SITE INSTRUCTION

PROJECT: HAMPTON MANOR

SITE INSTRUCTION NO.: E-26

PURPOSE: To suit mechanical SI M-20 & SI M-21.

GROUND FLOOR PLAN - B **ELECTRICAL**

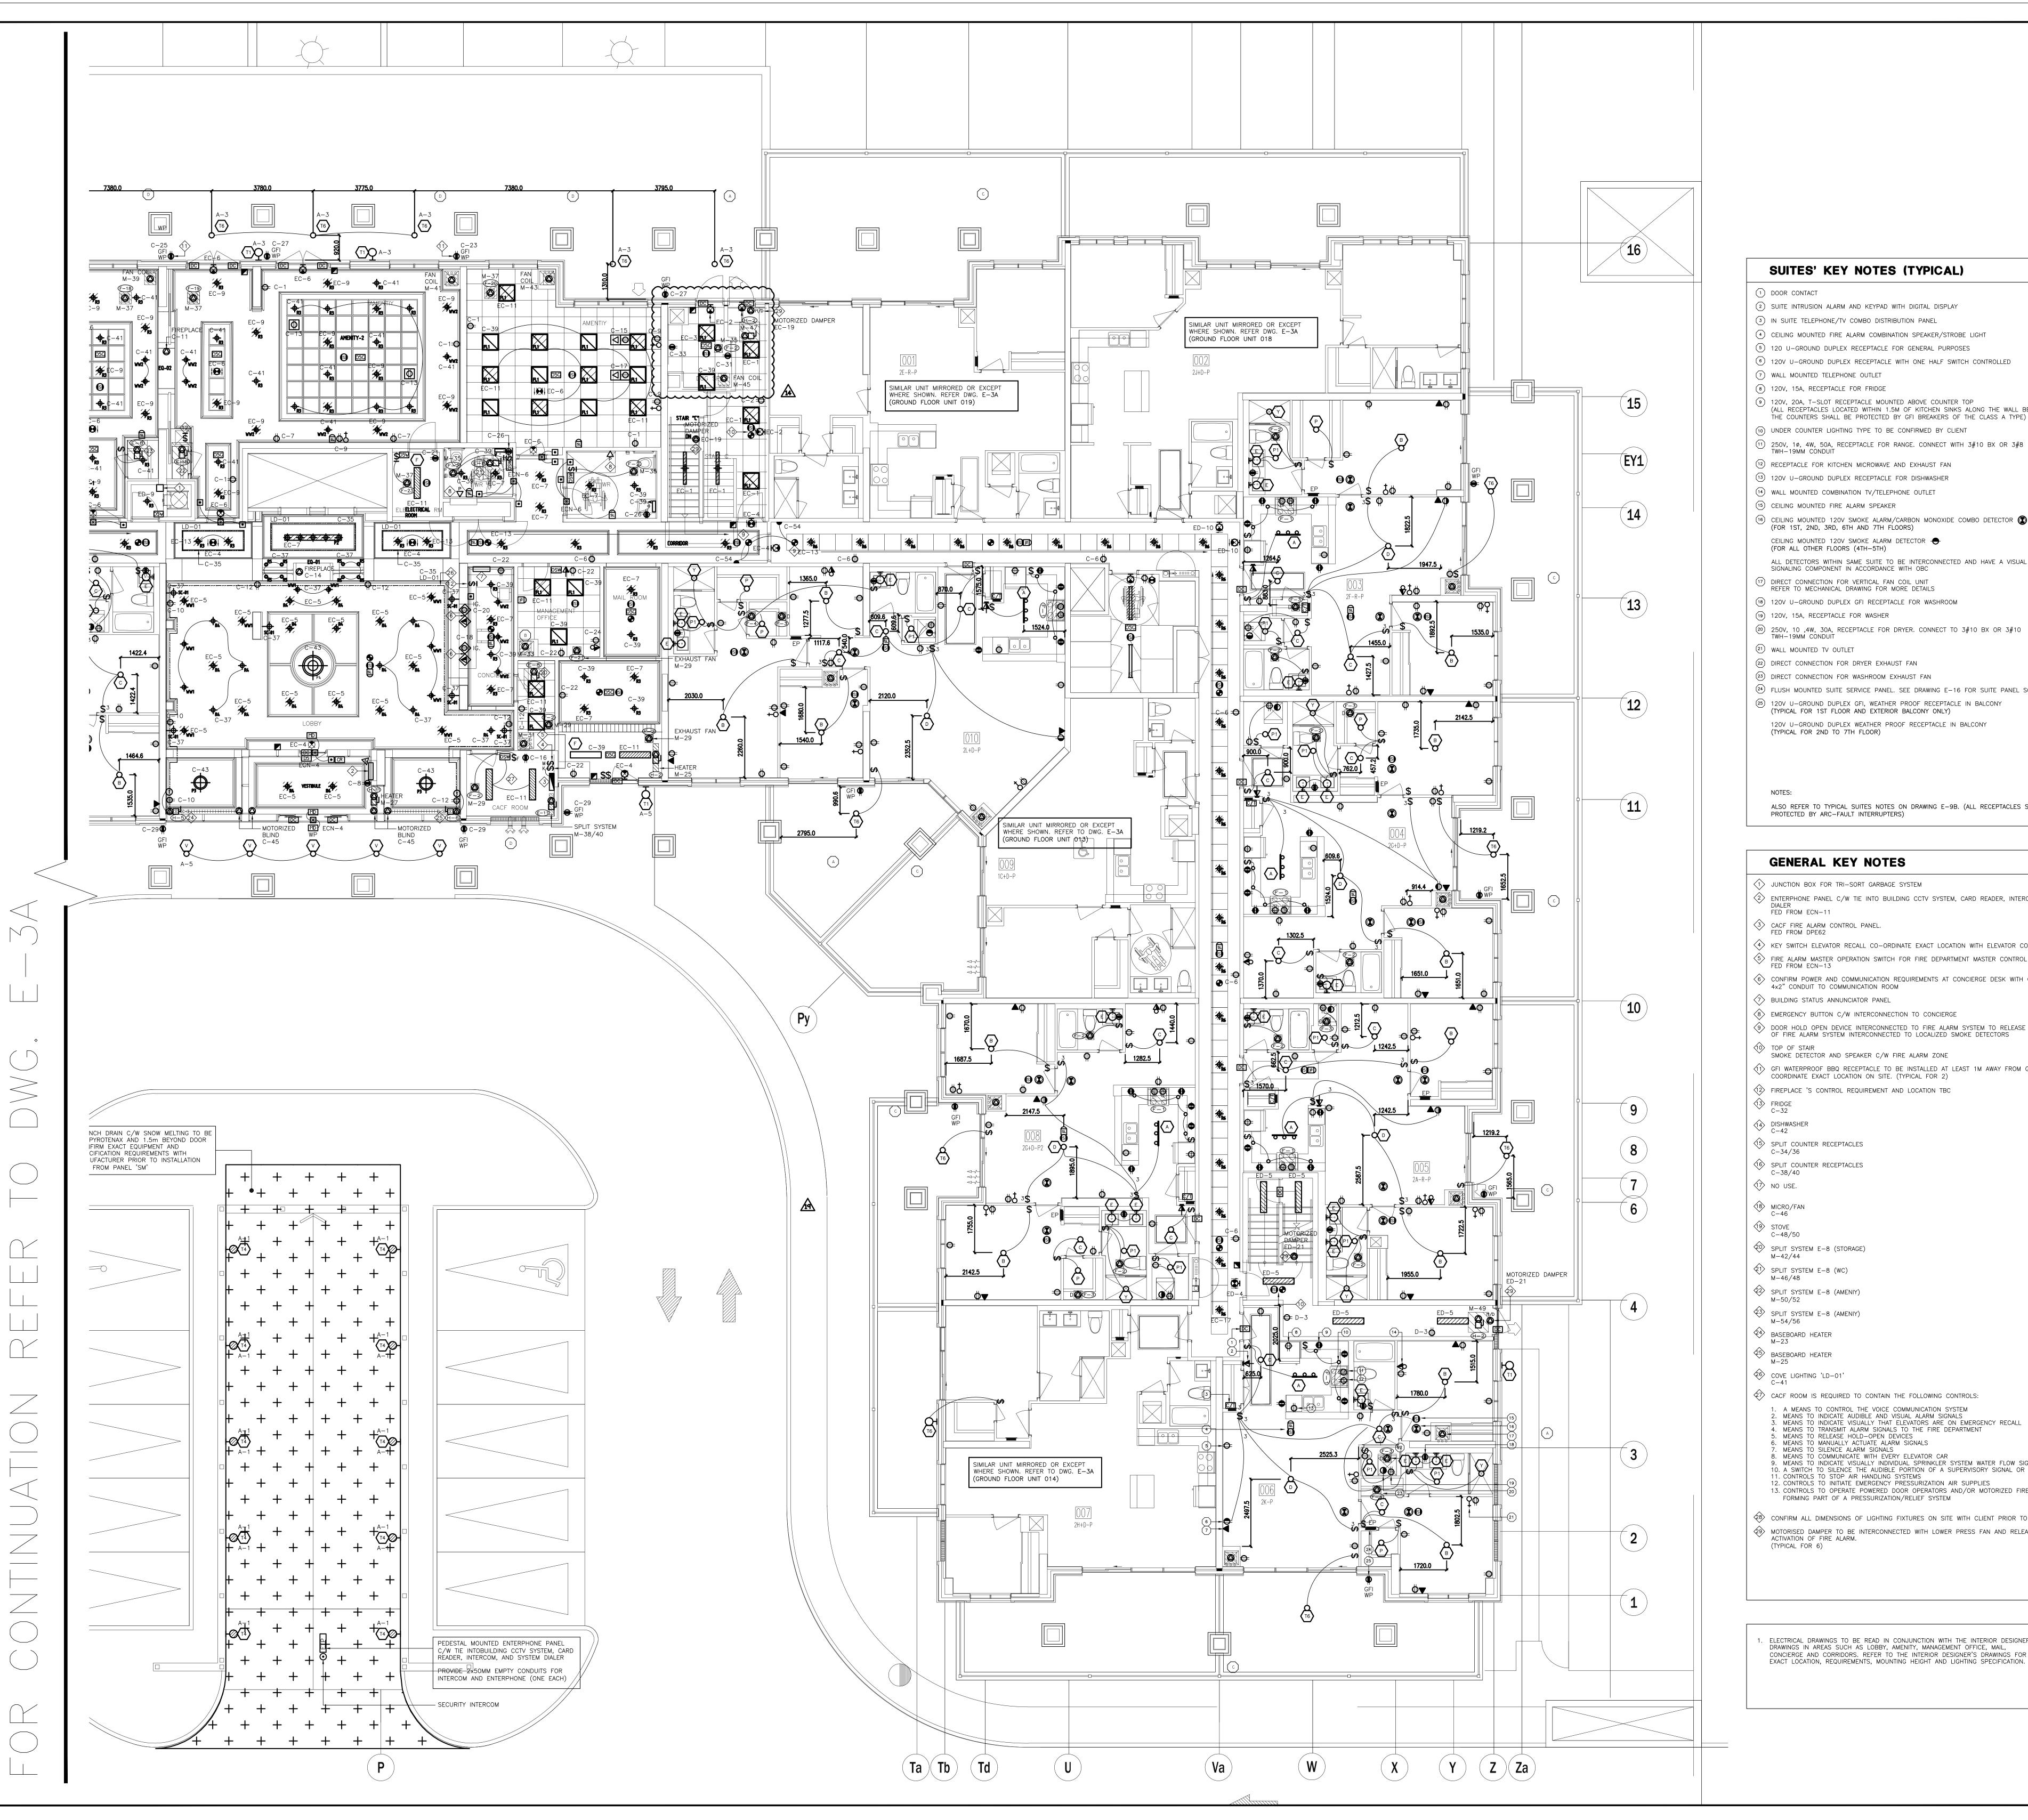
1.0 Reference Drawings E-3B (Ground floor B - Electrical) Issued

1.1 Relocate:

Exhaust fan F-2 and FCU #11 as per mechanical drawings.

SINGLE LINE DIAGRAM

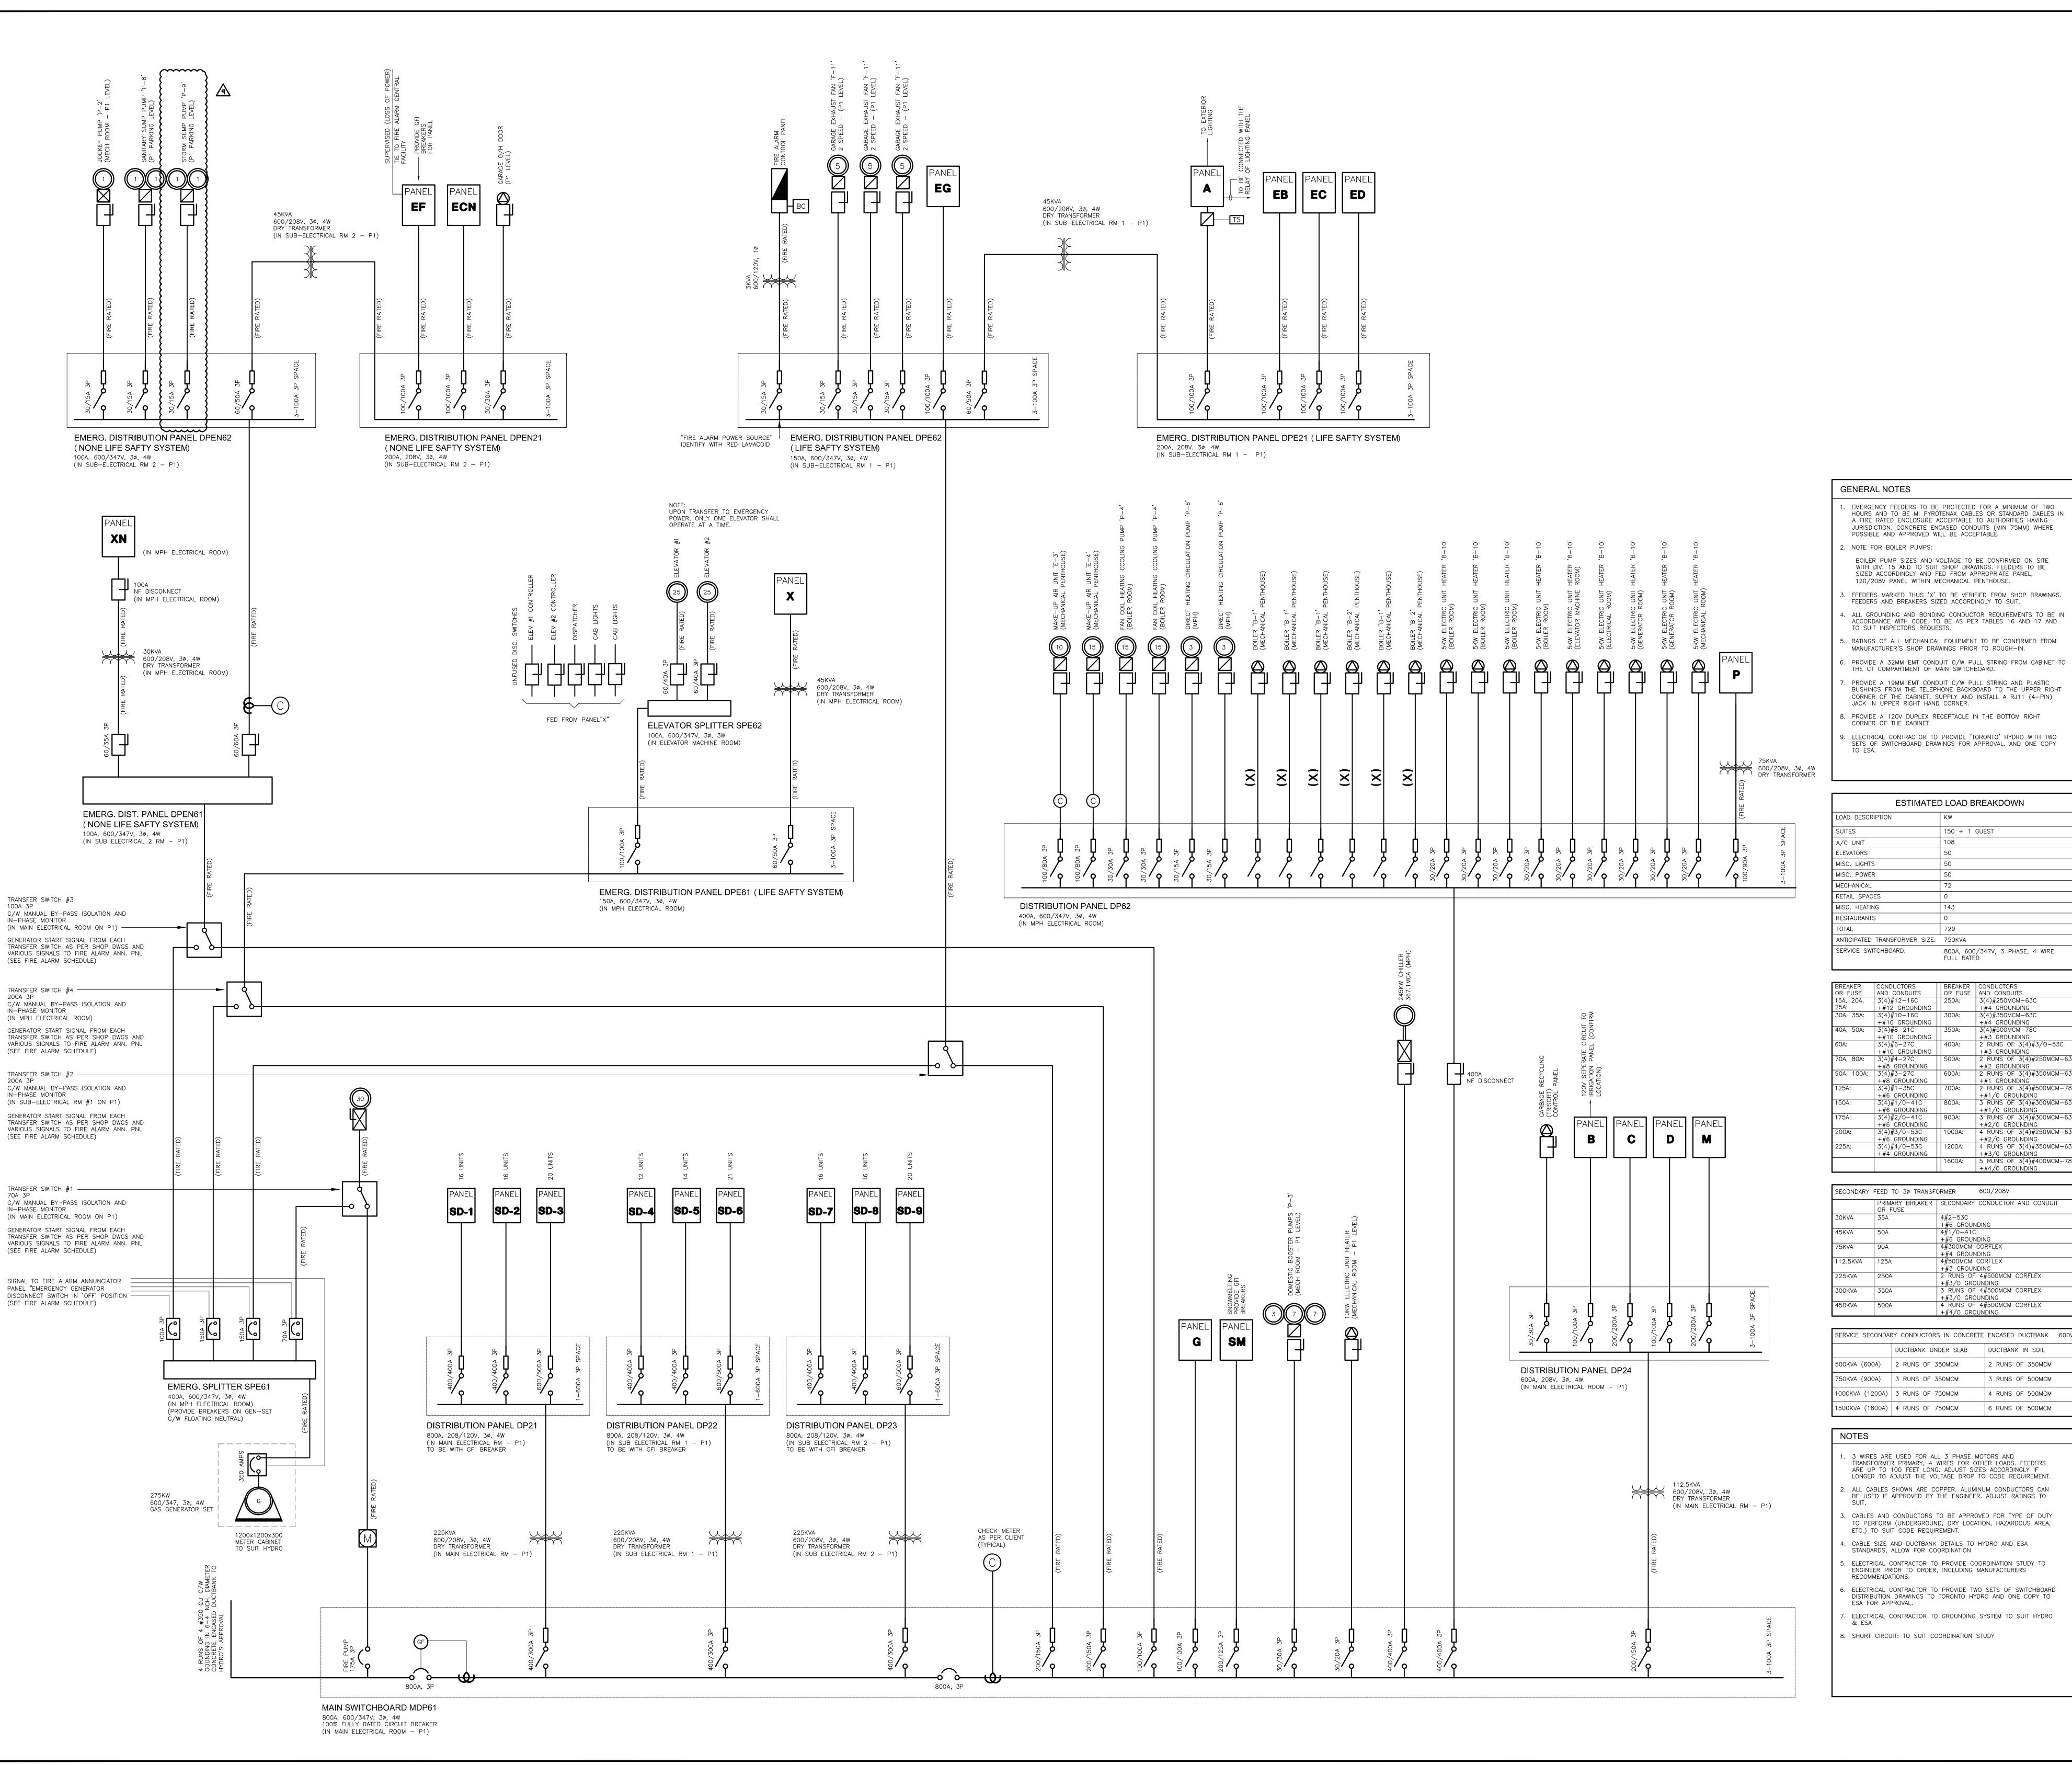
2.0 Reference Drawings E-11 (Single Line Diagram - Electrical) Issued

2.1 Revise:

Fusible disconnect switch and feeder size for storm pump P-9 as shown.
